E6651A Mobile WiMAX™ Test Set Revision History

epsg1109018

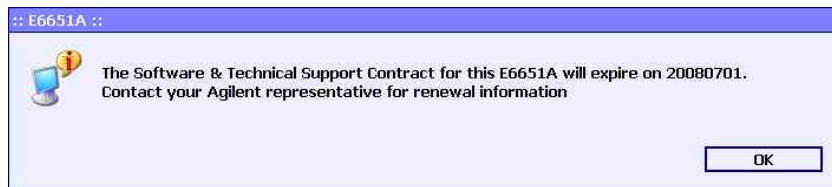
- The following screens are part of the E6651A option 1SY implementation:
 - To indicate the installation of the STSC license:

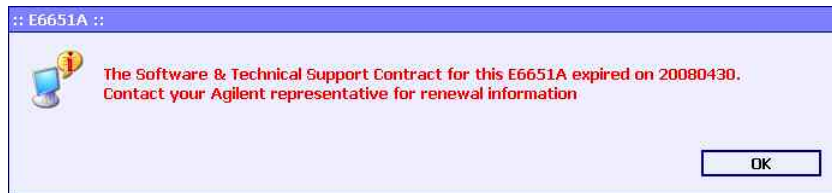
- 90 day warning of STSC license expiry. Contact your Agilent sales office for renewal of STSC if required:

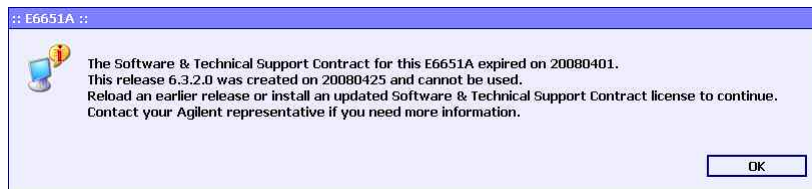
- Expiry of STSC license has been reached. No subsequent firmware updates can be installed on this Test Set:
